Access Compliance Report

Public Rights-of-Way

Intersection ID: 28068	Main Street: BORCHETTA_DR	Cross Street: MITCHELL_GLEN_DR	Location: NE
ADA ID: 792D2CA1AB99	Ramp Type: Perp	Initial Pass/Fail: Fail	Overall Compliance: No
Severity Score: 37.5			
Codes/Mitigation Info/Possible Solution		Field Measurements/Component Compliance

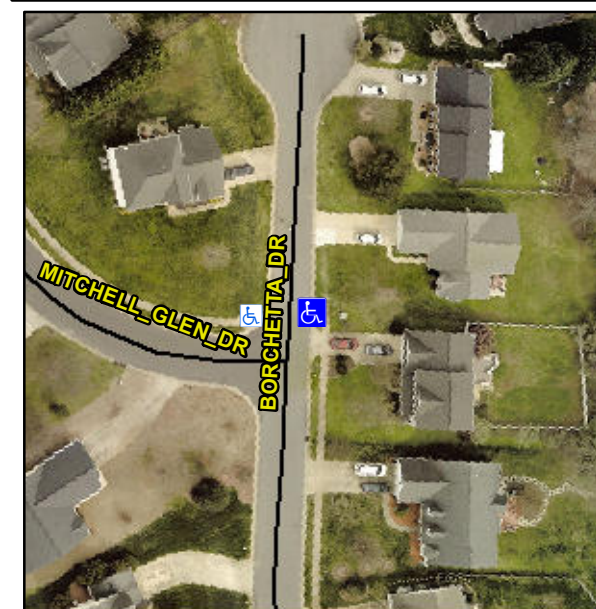
Remove & Replace Entire Ramp.

R304.2.2, R304.5.3

Compliance	Description	Data	Compliance	Description	Data
N/A	Ramp Length (in)	95.0	No	Ramp Slope (%)	10.2
Yes	Ramp Width (in)	48.0	No	Ramp XSlope (%)	8.1
N/A	Flare Type LT	N/A	N/A	Flare Type RT	N/A
N/A	Flare Slope LT (%)	N/A	N/A	Flare Slope RT (%)	N/A
N/A	Flare Traversable LT?	N/A	N/A	Flare Traversable RT?	N/A
N/A	Landing Length (in)	N/A	N/A	DWS Provided?	N/A
N/A	Landing Width (in)	N/A	N/A	DWS Contrast?	N/A
N/A	Landing Slope (%)	N/A	N/A	DWS Length (in)	N/A
N/A	Landing X Slope (%)	N/A	N/A	DWS Full Width?	N/A
N/A	Landing Curb? (Y/N)	N/A	N/A	DWS Offset (in)	N/A
N/A	Shared Landing?	N/A			
N/A	Gutter Ponding?	N/A	N/A	Gutter Slope (%)	N/A
N/A	Gutter Lip Ht (in)	N/A	N/A	Gutter X Slope (%)	N/A
N/A	Painted X Walk1?	No	N/A	Painted X Walk2?	N/A
	X Walk 1 Direction	To NW		X Walk 2 Direction	N/A
N/A	X Walk 1 Width (in)	N/A	N/A	X Walk 2 Width (in)	N/A
	X Walk 1 Slope (%)	2.7		X Walk 2 Slope (%)	N/A
	X Walk 1 X Slope (%)	3.3		X Walk 2 X Slope (%)	N/A
